V2500-A1/A5 SERIES NACELLE SERVICE BULLETIN

This document transmits Revision 1 to Service Bulletin NV2500-71-0277 and Revision 1 to the Supplement

V2500-NAC-71-0277

NACELLE – POWERPLANT – NOSECOWL – REPLACEMENT OF THE HOIST POINT BLANKING PLUGS

Removal of the Nosecowl – Hoist Point Blanking Plugs
Figure 1

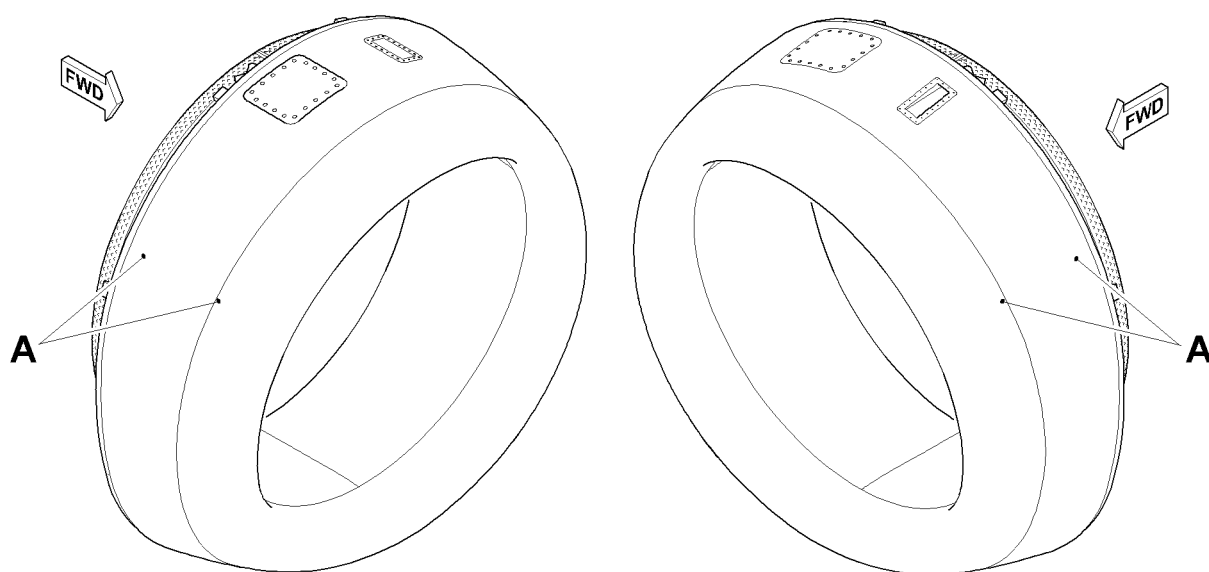
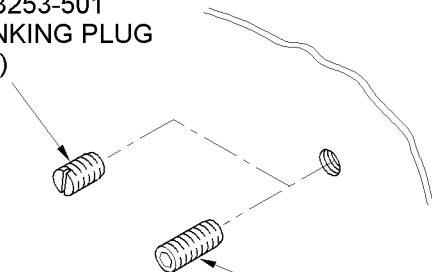
| <p>(a) Identify the four old 740-3253-501 Blanking Plugs in their respective locations on the Nosecowl.</p> | <p>The Blanking Plugs are located on the Nosecowl looking Aft in the 2 o'clock and 10 o'clock positions. Refer to Figure 1.</p> |

REMOVE
740-3253-501
BLANKING PLUG
(4 off)

(e) Install four new AN565AC624H16 Blanking Plugs in place of the four old 740-3253-501 Blanking Plugs on the Nosecowl.

INSTALL
AN565AC624H16
BLANKING PLUG
(4 off)
